## **Piblinell HyNet a HN1.7 – Holywell Road / Green Lane, Ewlo**

**Planning Act 2008 (as amended) and The Infrastructure Planning (Environmental Impact Assessment) Regulations 2017 – Regulations 10 and 11 Scoping Request made on behalf of Liverpool Bay CSS Limited for an Order granting Development Consent for the HyNet North West Carbon Dioxide Pipeline proposed from Cheshire, England to Flintshire, Wales.**

**Supplementary Local Authority Response: The Deposit Flintshire LDP**

HyNet Pipeline and Housing Allocation Ewloe

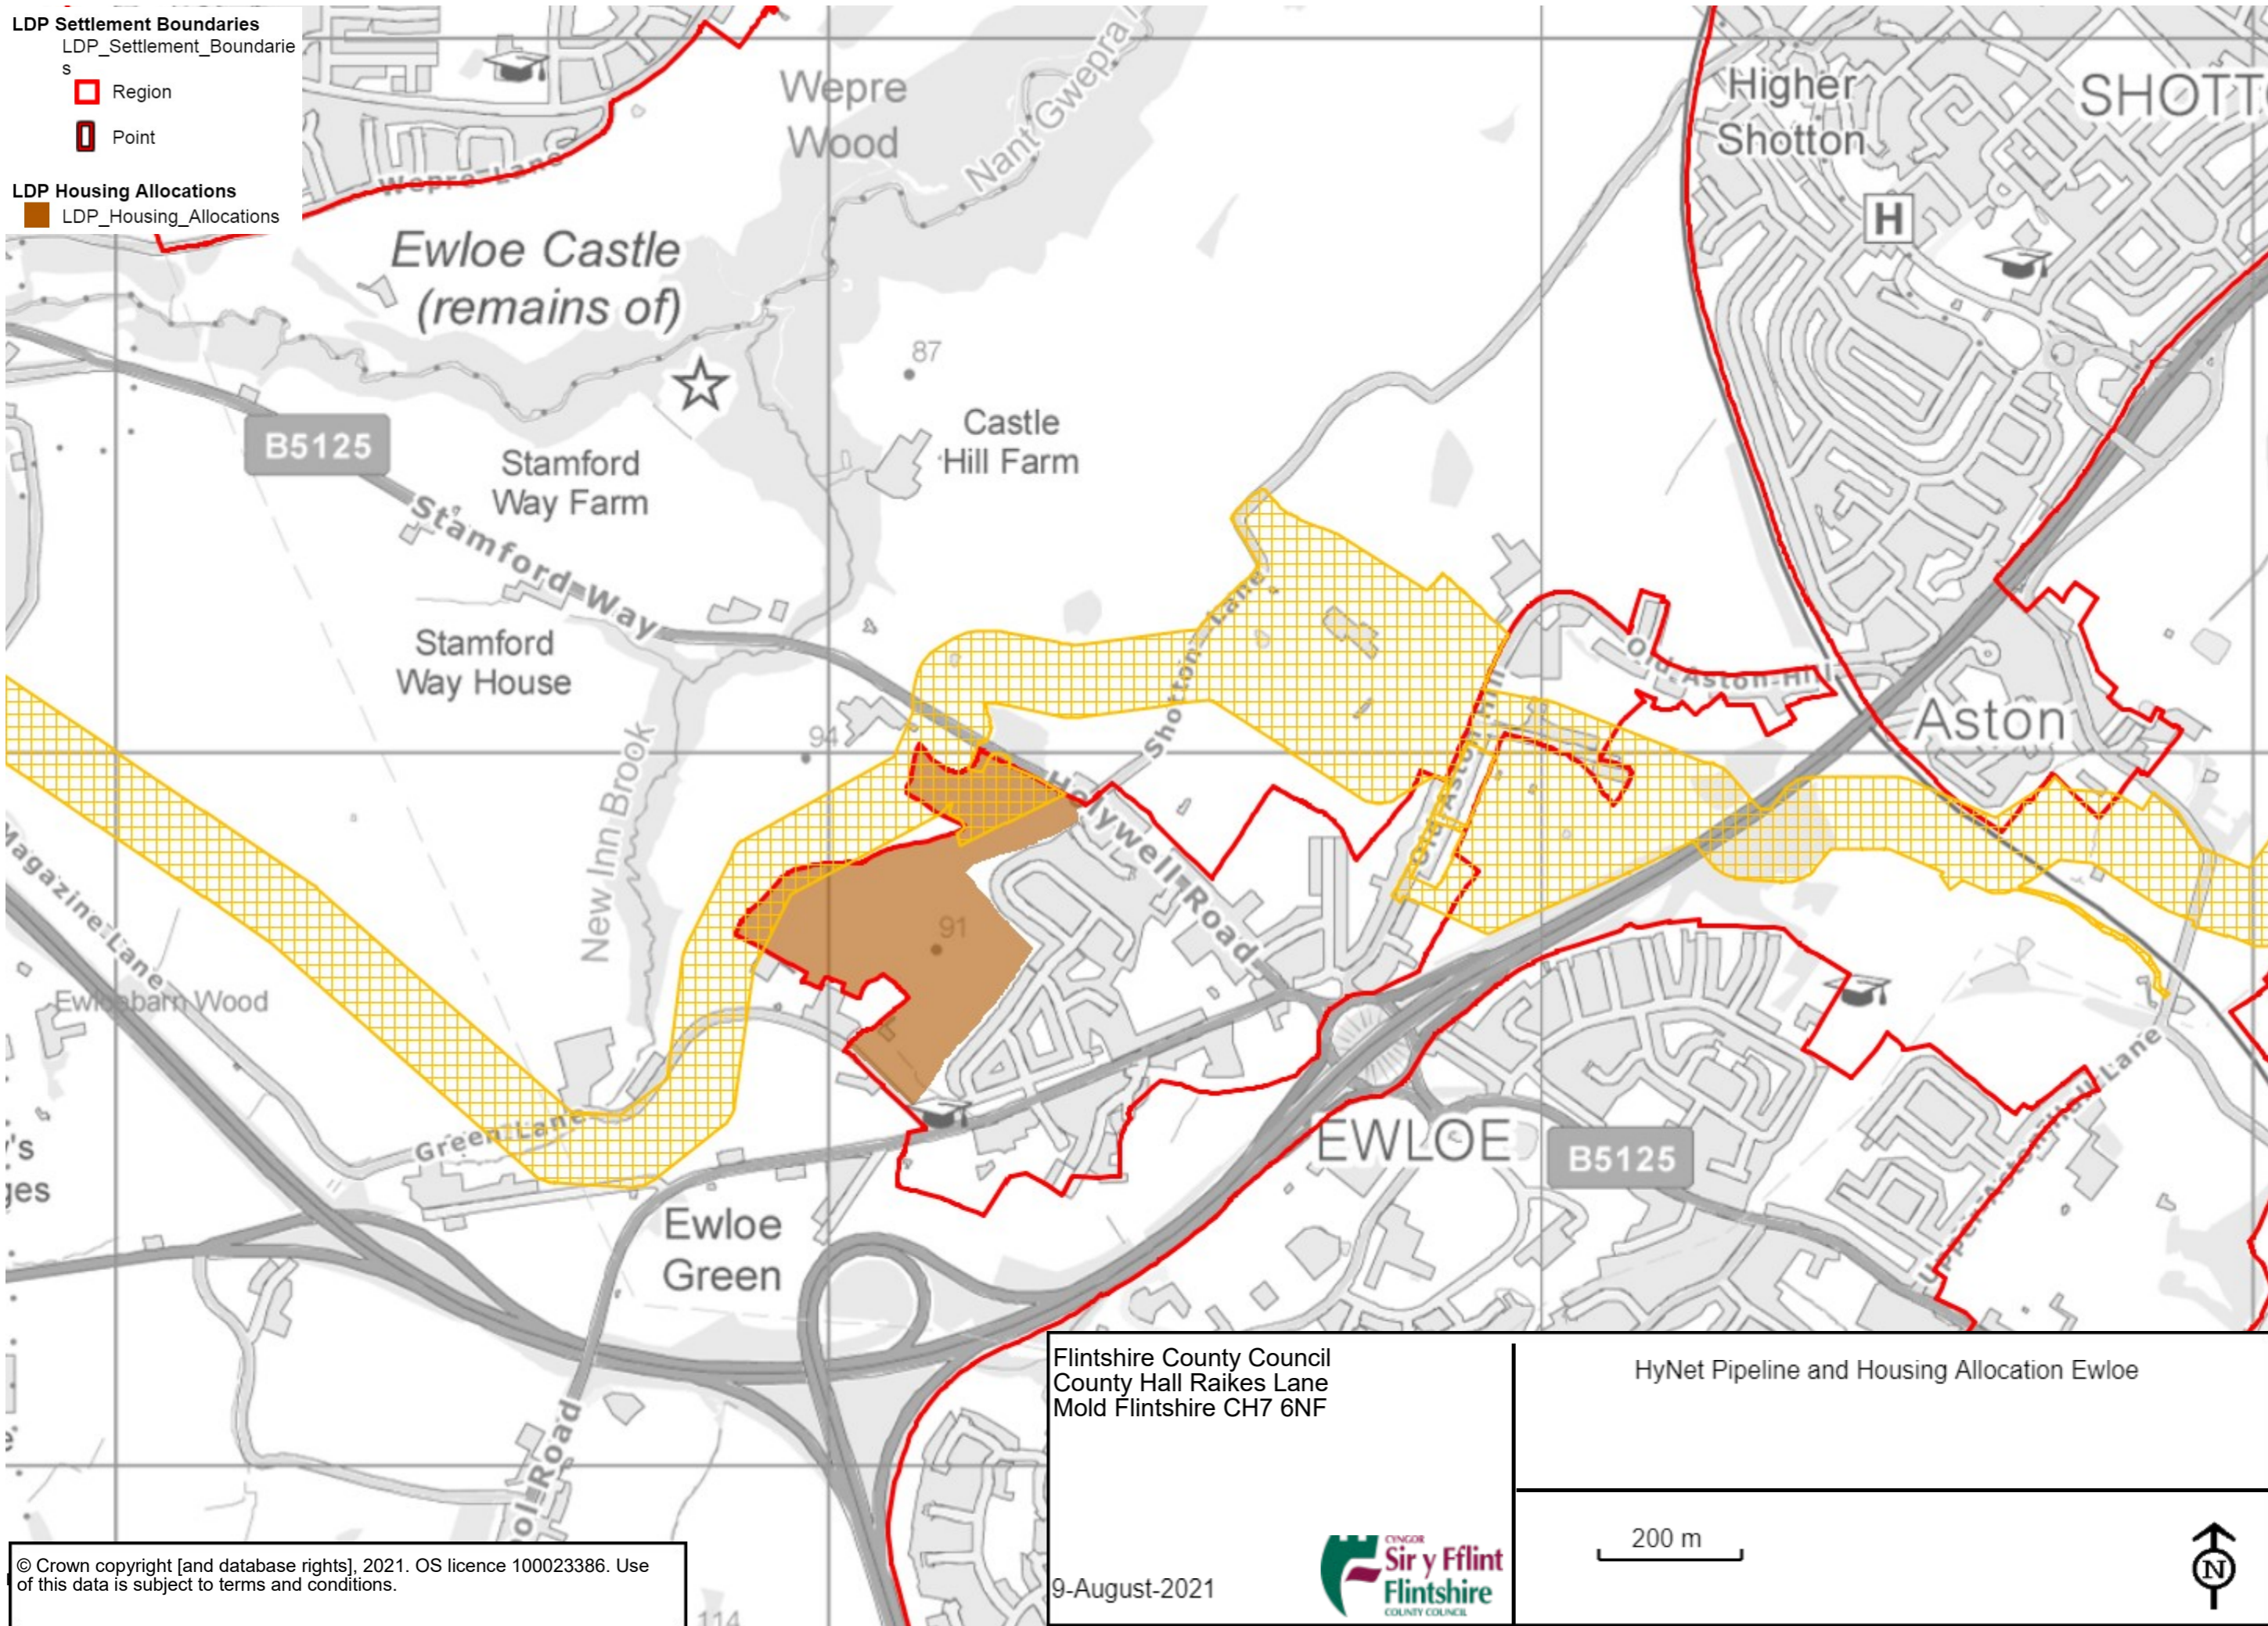
The enclosed pdf shows that the proposed route conflicts with a proportion of the housing allocation 'HN1.7 Holywell Rd / Green Lane, Ewloe' proposed to the north west of Ewloe. This would therefore have an impact on the proposed housing numbers that the allocation could provide, which is fundamental to the housing provision of the Flintshire LDP. The Examination Inspector has been presented evidence in relation to this housing allocation, and has already examined this allocation as part of the Housing hearing session. There is no reason before us why the Flintshire LDP should not include this housing allocation as proposed.
